King William Road Bikeway

Detailed Design Advice

Our design feedback is structured in terms of some broad operational aspects, then comments reflecting the northern and southern sections of the design, as reflected in cross-sections provided for sections A and B.

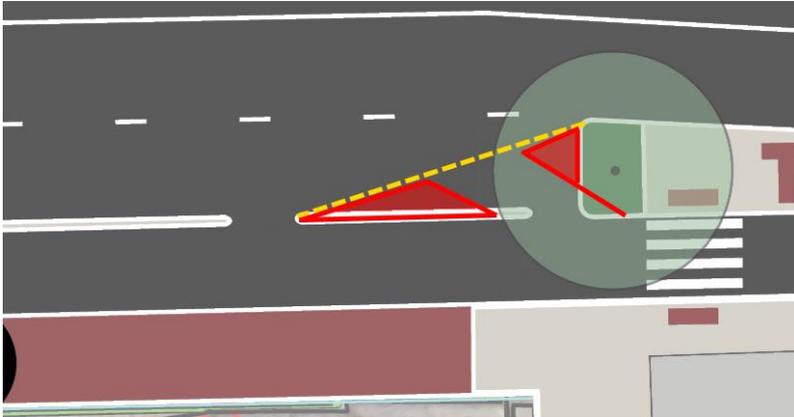
8. Right turn bike box

This is a useful feature, given that many cyclists access the Park Lands path to the north-east. However, it appears that the only way to enter the facility from the separated bike lane is through a gap in the separator at the forward storage area. Given that cyclists could be waiting two abreast over this gap, or flowing quickly in a through direction, such access would be difficult and the right turn box close to unusable.

Locating the gap further south to be level with the car holding line would assist in enabling access, particularly in conjunction with a wider bike lane – which is feasible with space recovered from the wide lanes on the eastern side of King William Rd. A 3m bike lane + 0.3m separator would cater for two abreast cycling generally but three abreast access at low speed, i.e. when cyclists are stopped and queued. 0.9m on

the right-hand side could then be line-marked as a right turn lane for cyclists, for a length of up to about 20m (it is narrow for longer distance travel, especially given the adjacent separator kerbing).

An additional minor improvement could be made by line-marking car guidance to enter the left-turn lane and design around this to create a protected area for cyclists, as shown in the following diagram.

Figure 4.3: Typical bicycle/car parking lanes layout (parallel parking)

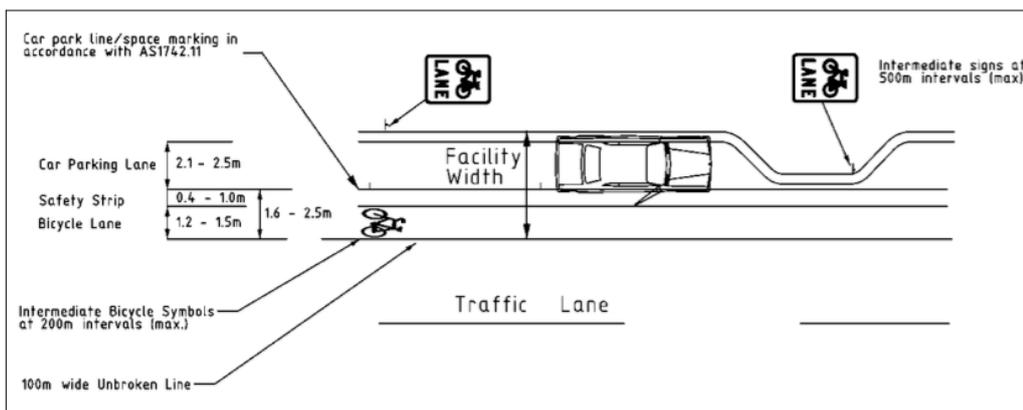
From Austroads, a buffer ('safety strip') between parallel parking and a general bicycle lane should be 0.4-1.0m wide, as follows.

To cater for demand in King William Rd, the buffered bike lane should be 2.0m to allow for overtaking. In this case, the painted buffer would provide space that could be considered to include the clearance to the footpath kerb and to the cars, when it is used by overtaking cyclists. While this would put such cyclists within the door zone, car doors opening into bicycle traffic would be rarer for a buffered bike lane than a unbuffered bike lane as the vehicle occupancy of around 1.1 people/car in Adelaide means that only some 1 in 10 cars have a passenger. Nonetheless, 2.0m + 0.4m buffer does not allow for any variability in parking. (A greater width is desirable and possibly achievable in some locations, around other road feature transitions.)

Option 1 shows a 1.4m bike lane plus 0.5m buffer i.e. allocated space of only 1.9m. We have identified two alternatives to achieve the required separated bike lane width.

a) Western footpath

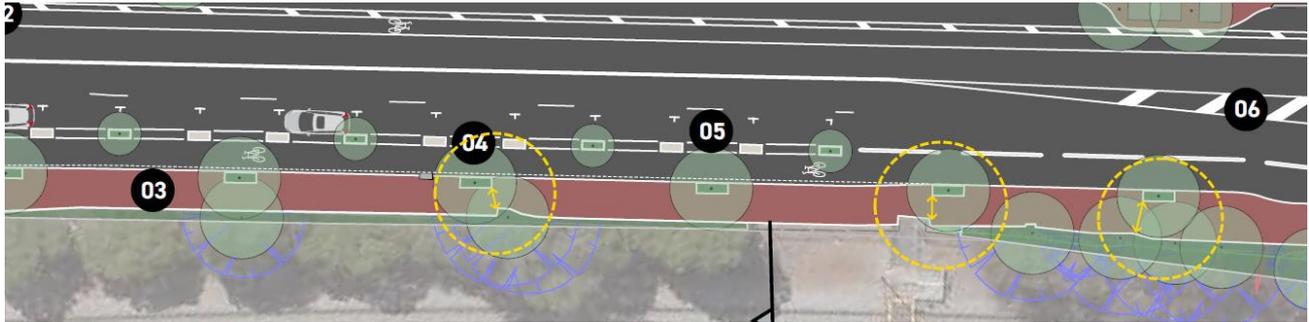
The footpath width is some 3.3m – which is greater than the 2.4m footpath further north. Given that the project will change what is currently a shared use path to a footpath, this is one of the rare cases where we would advocate for a reduction in footpath width in favour of the space required for the buffered bike lane. This would reduce the footpath width to below 3.0m. However, there are a few locations where tree placement would create ‘squeeze points’ along the footpath, as shown following. Relocating tree plantings could offset the footpath narrowing by increasing the usable width.

As noted for section A, the western separated bike lane could be reduced from 2.5m to 2.4m as long as the kerb to the footpath and the separator both have laid-back rather than upright profiles.

11. Bicycle refuge, Mike Turtur Bikeway crossing

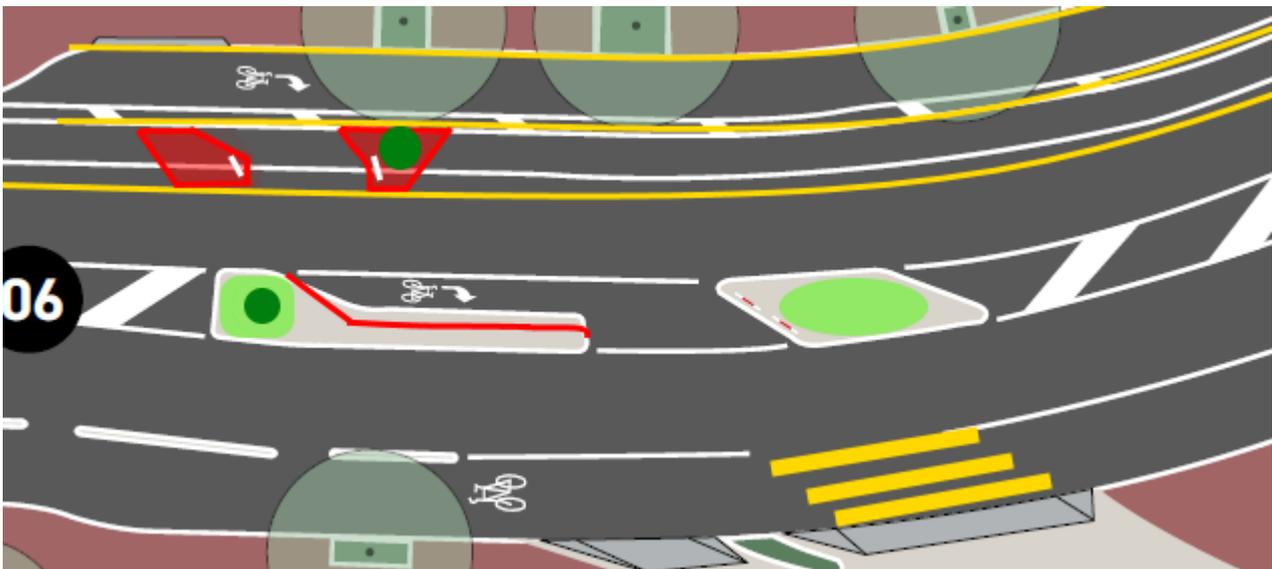
This bicycle refuge is based on a bicycle lane rather than buffered bike lane, hence requires redesign. A general concept follows, with the following features:

- Cyclists turning right into the Bikeway are given a protected area in which to conveniently pull off the separated path to its right, rather than needing to pull into a bay on the left and then cross both cyclists and traffic. This allows for ease of access into the refuge, but also (short) holding rails if they need to wait to give way to traffic. As the traffic is one-way in regard to cyclist yielding and sightlines, the southern kerb extension could feature a small tree.
- The central refuge is wide, presumably to cater for likely demand. However, the actual bike ‘lane’ section of this is relatively narrow. This could be widened to enable cyclists to locate further from southbound through traffic. A rail located in the nose of this northern section of refuge would assist

cyclists waiting here, increasing the capacity of the refuge. The refuge is wide enough to present low-level landscaping opportunities (light green), including a small tree on the northern end (dark green) given that cyclists are not travelling from the right of southbound through traffic and this would not impede required sightlines.

- The width of the refuge is not shown. There may be some opportunity/desirability to reduce the width slightly to provide width to other priorities, however this should be carefully considered.
- We suggest that the area on the west shown with indicative 'zebra' line-marking should be treated to highlight this as a crossing point to through cyclists. This could be using green Streetprint, as previously mentioned, without necessarily providing priority. A section where cyclists exit the Mike Turtur into the separated bike lane is also advisable (this, in particular, could be a decorative pattern that simply highlights the location rather than attempts to manage it.) And similarly for the southbound separated bike lane where cyclists slow to turn off into the crossing to the Mike Turtur.
